HINCKLEY RAIL FREIGHT TERMINAL

Comments following 24 January 2024 Hearing

CPRE Leicestershire

February 2024

Figure E5: South-West Leicestershire Screenlines and Journey Time Routes

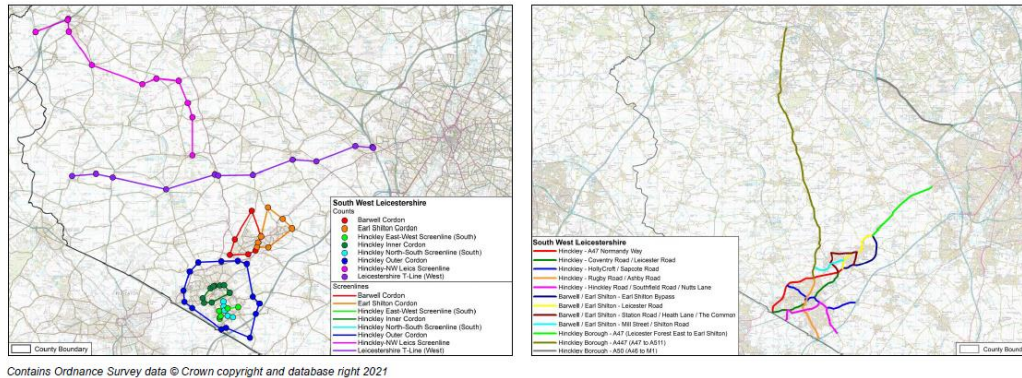
2.17 Figure E5 of the Validation Report specifically identifies the count points around Hinckley. Notably, these do not include count points beyond the M69 on the B4669 to Sapcote. We are relying on an assumed dissipation of traffic from that point onwards.
